Re: Petition No. 1104 - The United Illuminating Company Petition for a Declaratory Ruling that no Certificate of Environmental Compatibility and Public Need is Required for the Construction, Operation and Maintenance of a 2.2 MW AC Solar Photovoltaic Facility and a 2.8 MW AC Fuel Cell Facility on Seaside Landfill Located at 350 Waldemere Avenue, Bridgeport, Connecticut

I enclose an original and fifteen (15) copies of The United Illuminating Company's ("UI") responses to the Siting Council's February 24, 2015 interrogatories concerning UI's Development and Management Plan that was submitted to the Council on February 5, 2015.

REVISED 2/25/2015
UI SEASIDE LANDFILL - BRIDGEPORT, CT
GROUND MOUNTED SOLAR ARRAY
PROPOSED DEVELOPMENT PLAN

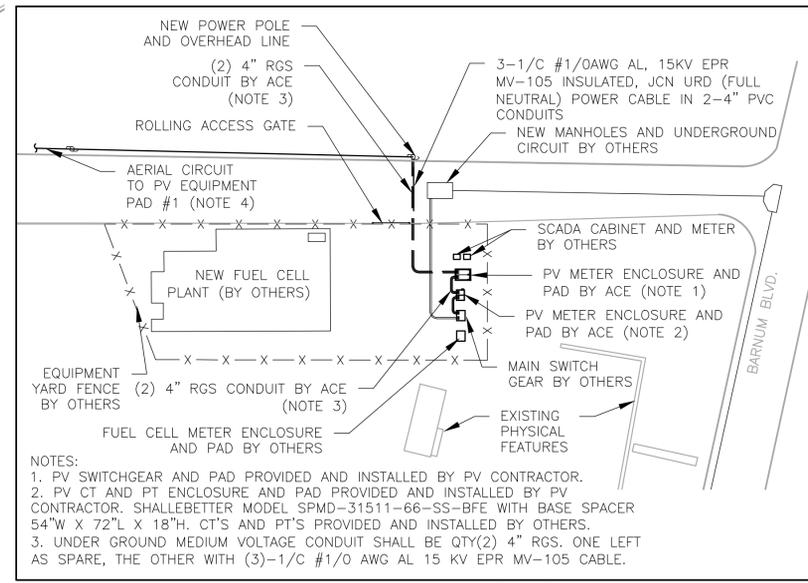
- a) Provide the dimensions/weight for the above ground cable tray and conduit supports.
- b) What are the dimensions of the proposed inverter pads? What is the excavation depth?
- c) What type of fence post mount will be used? If not known, what study is necessary before determining the type of mount?
- d) When will the panel and racking manufacturer be selected? Does the manufacturer specify the ballast size? What is the approximate size of each ballast?

b) There are four proposed equipment pads on the landfill cap. The approximate dimensions of each pad are:

1. 34' x 15' x 0.833'
2. 16' x 13' x 0.833'
3. 15' x 21' x 0.833'
4. 15' x 21' x 0.833'

The maximum excavation depth for the equipment pads is 9 inches from grade, or 3 inches from the bottom of the vegetative support layer.

DWG #:
C-4
 REV 0.3

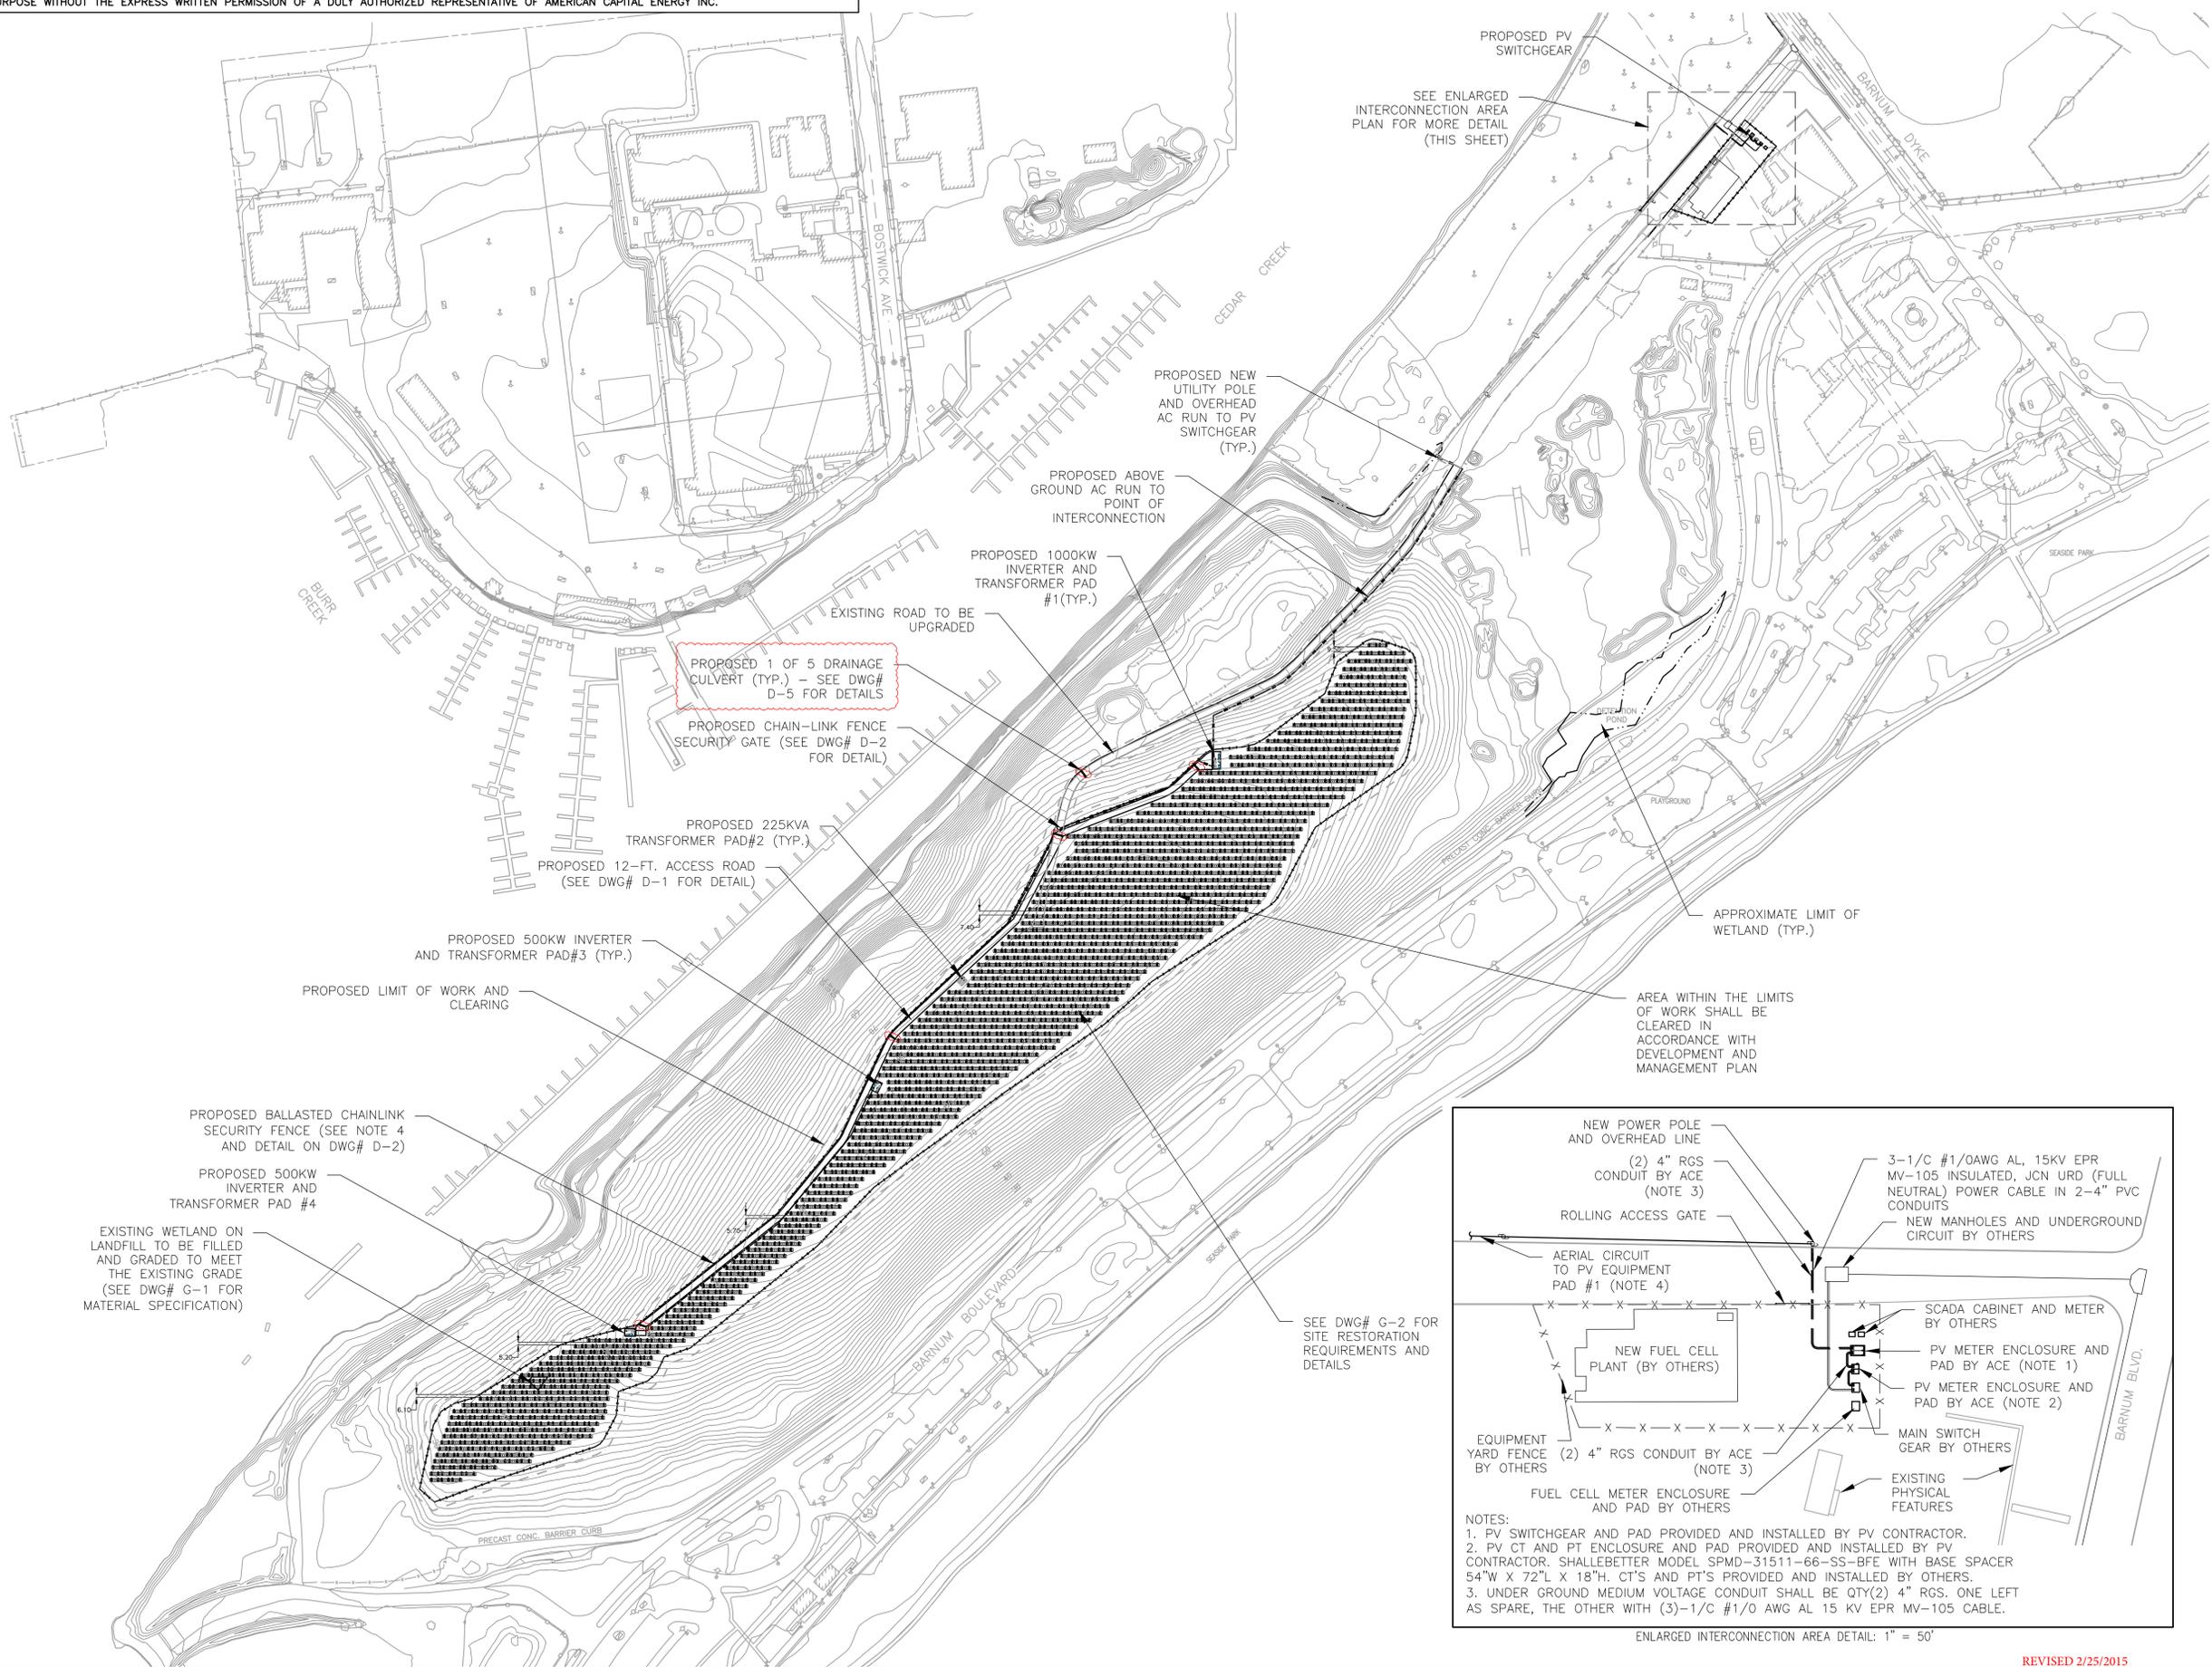
Q-CSC-DM-5: D&M Site Plan Sheet C-4 – What type of fill is specified for the wetland area? How will the fill be compacted prior to the solar installation?

Q-CSC-DM-6: D&M Site Plan Sheet D-2 – in regards to the Culvert Crossing Detail, please indicate the locations of the culverts and provide pipe dimensions, and excavation and/or fill details.

A-CSC-DM-5: The wetland located on the landfill will have the existing vegetative support layer stripped, exposing the low permeability layer. This material will be stockpiled on-site, separated from the existing grade using plywood or plastic. Additional low permeability material will be added and compacted in 6-inch lifts to a height that allows for positive drainage. The stockpiled vegetative support material will be reused, compacted, and graded to match the existing surrounding grade. All work related to the landfill will be performed under the supervision of the on-site engineer and completed prior to the installation of the PV equipment within the immediate area. The area will be hydro-mulched .

A-CSC-DM-6: The Culvert Road Crossing locations have been identified on the revised C-4 Sheet (attached). A 12-inch ductile iron pipe is recommended. A 10:1 slope of dense graded material will be built up on either side of the culvert. A stone apron is recommended to reduce outlet velocity and concentration of run-off.
